Date: December 12, 2003
 To: T10 Committee (SCSI)
 From: Jim Coomes (Seagate)
 Subject: SBC Obsolete Third Party XOR Commands

This is a proposal to obsolete the third party XOR commands.

2 Changes to SBC-2 r11

Figure 0.1 — Update write operation (third-party)

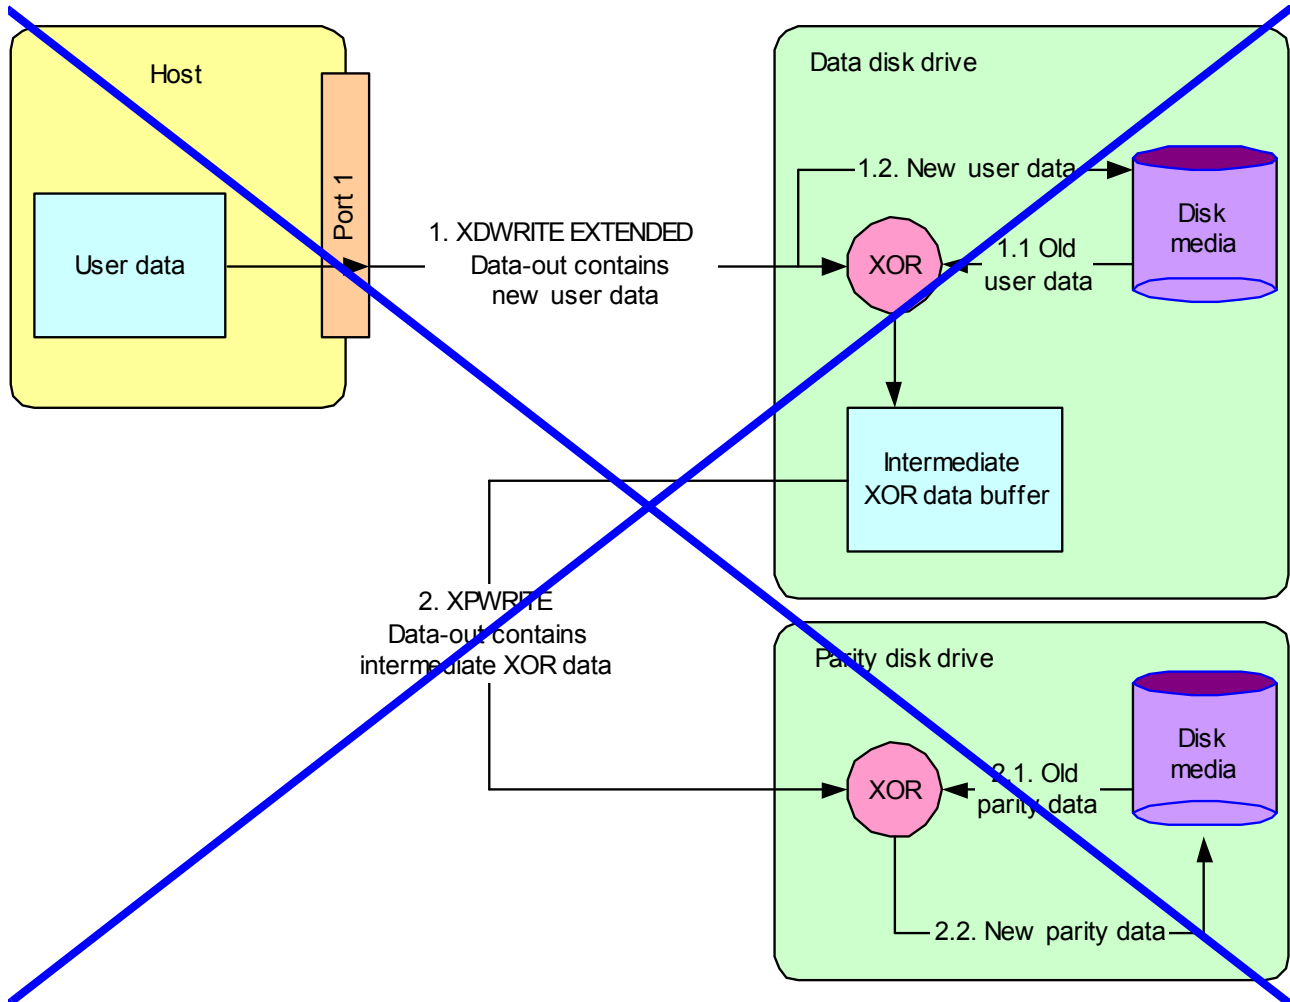
~~Figure 0.1 illustrates a third party read modify write operation. The example uses a host, a data disk device (holding protected user data), and a parity disk device (holding check data). In this example, the data and parity devices are on the same SCSI physical interconnect, and thus are capable of peer to peer interaction. Two SCSI commands are used: XDWRITE EXTENDED and XPWRITE.~~

Figure 0.2 — Regenerate operation (third party)

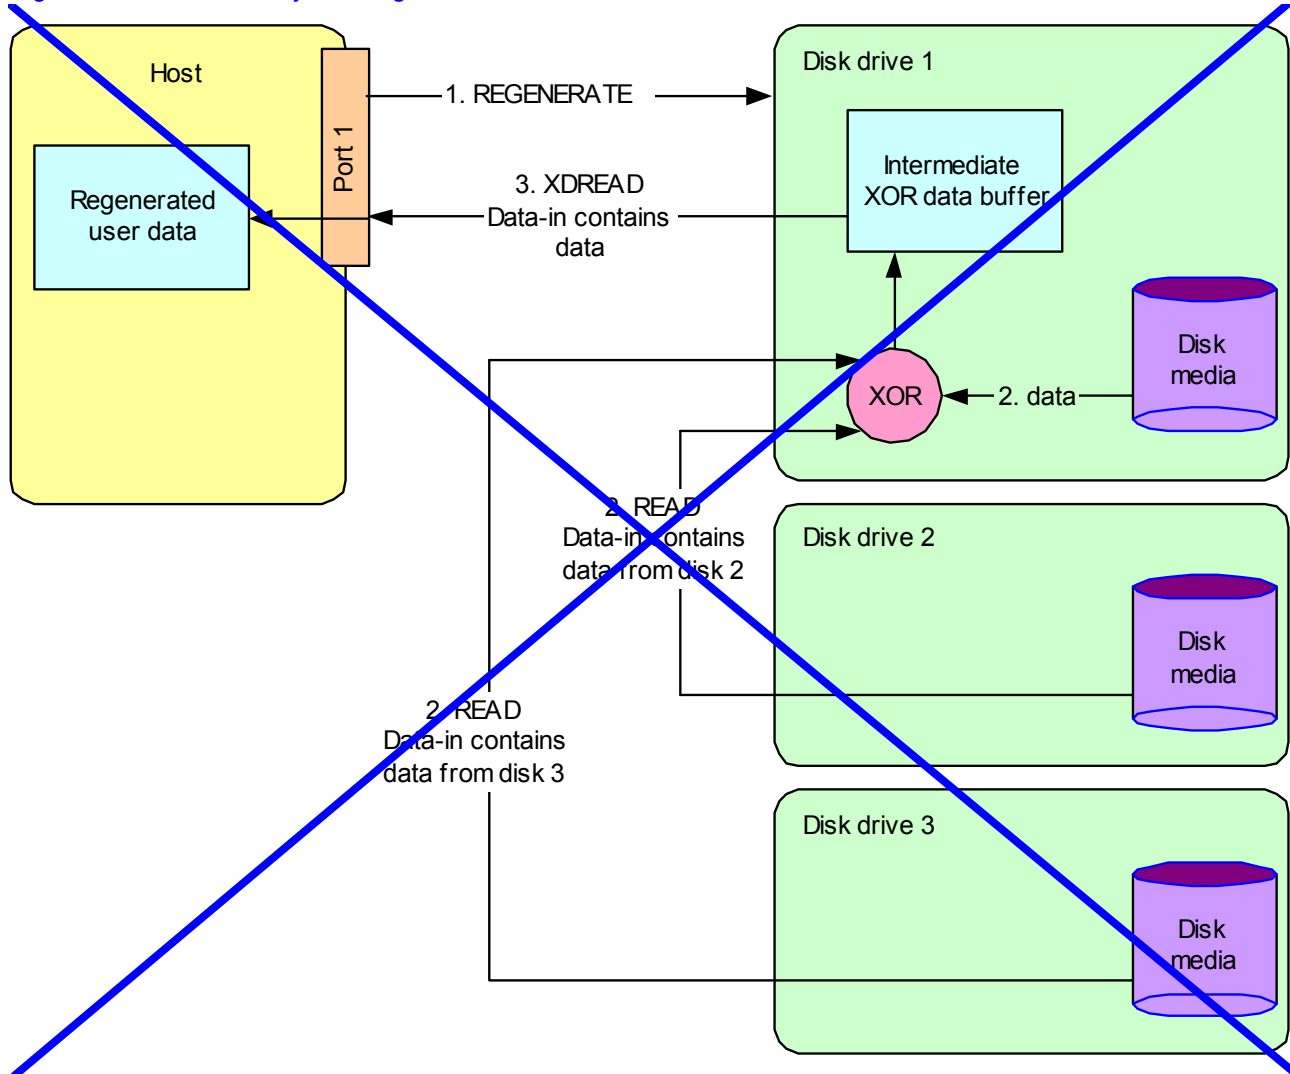
Figure 0.2 illustrates a third-party regenerate operation. The example uses a host and three disk devices. In this example, all three disk devices are on the same SCSI physical interconnect, and thus are capable of peer to peer interaction. Three SCSI commands are used: REGENERATE, READ, and XDREAD.

Figure 0.3 — Rebuild operation (third party)

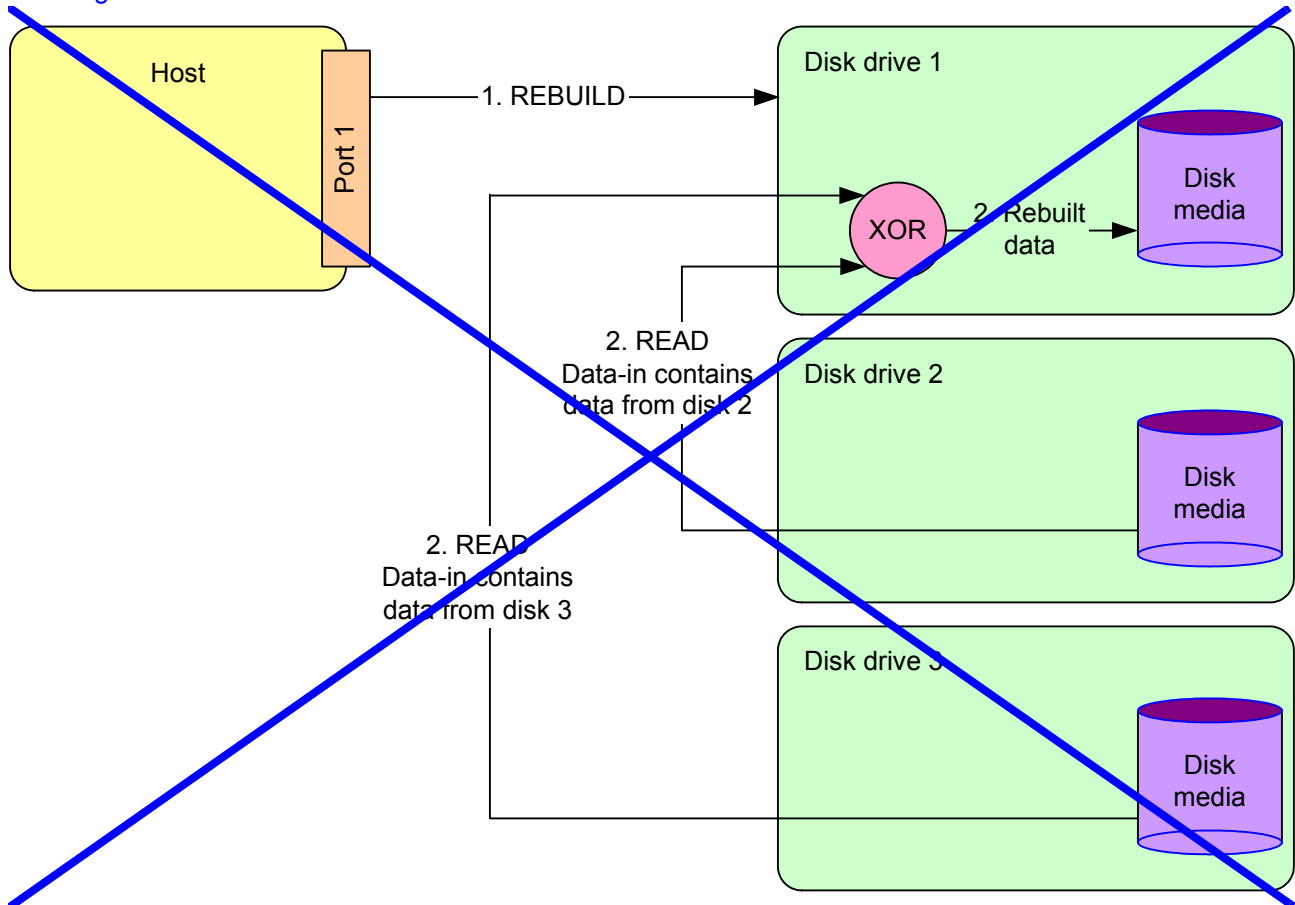
Figure 0.3 illustrates a third party rebuild operation. The example uses a host, two disk devices as the source devices, and one disk device as the device being rebuilt. In this example, all three disk devices are on the same SCSI physical interconnect, and thus are capable of peer to peer interaction. Two SCSI commands are used: REBUILD and READ.
